#### 49 CFR Part 571

[Docket No. NHTSA-2010-0021]

### Federal Motor Vehicle Safety Standards; Electric-Powered Vehicles; Electrolyte Spillage and Electrical Shock Protection

**ACTION:** Final rule.

Figure 1. S7.6.3 and S7.7 Measurement of Voltage Source Voltage

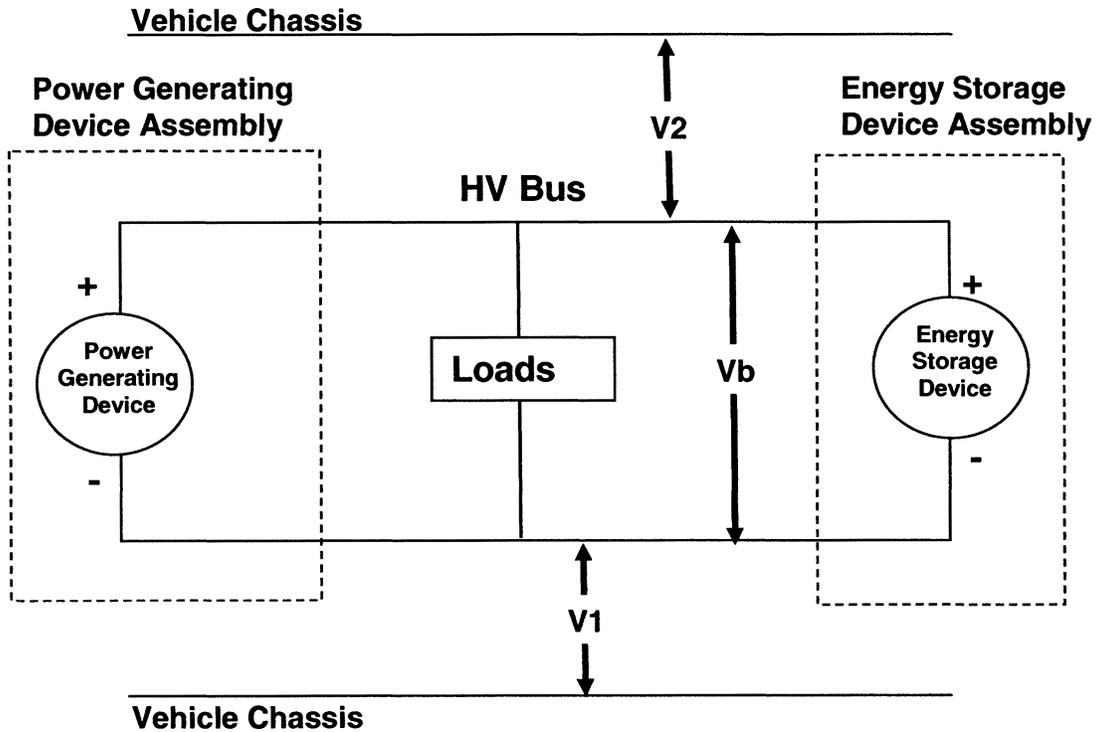
And fifth, the Alliance/AIAM suggested the following editorial corrections: Figure 1 should refer to S7.6.3, not S7.6.6; in Figure 4, V1 should be V1', and the denominator should be V1'; and in Figure 5, the denominator should be V2'.

We agree with these corrections and have revised the regulatory text accordingly.
